## Citizens' Oversight Projects (COPs)

August 30, 2018

Victor Dricks  
Sr. Public Affairs Officer  
Office of Public Affairs, Region IV  
Nuclear Regulatory Commission  
Arlington, TX, 76011-4511  
Email: victor.dricks@nrc.gov

The NRC announced a "Special Inspection" at San Onofre Nuclear Generating Station to review events surrounding the Aug 3, 2018, fuel-loading "near miss" incident. Through this letter we hope to provide guidance to this investigation by the NRC from our standpoint of providing public oversight, including a request for expanding the scope of your investigation. Please distribute this letter appropriately within the NRC so our concerns will be known by the inspection team.

*Figure 1: Transporter lowering an MPC canister into an underground vault protected by Transfer Cask*

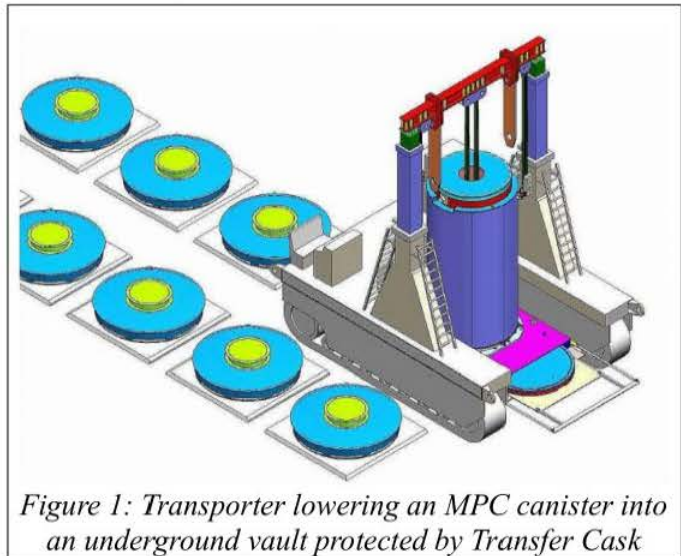
Once over the underground vault, the bottom of the transfer cask has a sliding door that can move out of the way so the MPC-37 canister can be lowered into the vault. (Figure 1).

*Figure 2: Arrow shows location of alignment ring which was supporting the entire ~45 ton mass on about 1/4" from falling about 18 feet into the vault.*

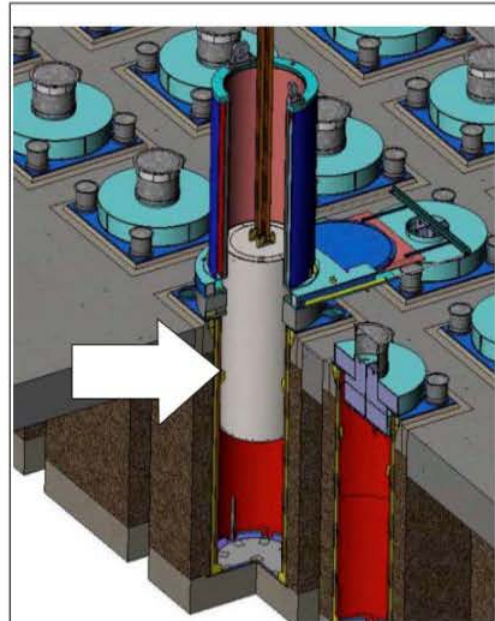
The rigging holding the canister lowered all the way, and workers thought the canister had successfully been lowered into the vault. However, the bottom of the canister had become lodged on the top of the MPC Guide Ring, which exists about four feet from the top of the vault, and the MPC canister was only barely held by about 1/4 inch from falling about 18 feet into the vault. (Figure 2).

Some have commented that there was no risk to the public in this near miss incident. We disagree. This event **could have been a major disaster**, and it is one that has not been adequately modeled nor is there any plan to deal with it.

6. **REDESIGN:** Holtec should change their design of the spent fuel system so that:
    1. It is impossible for a canister get stuck in the lowering process
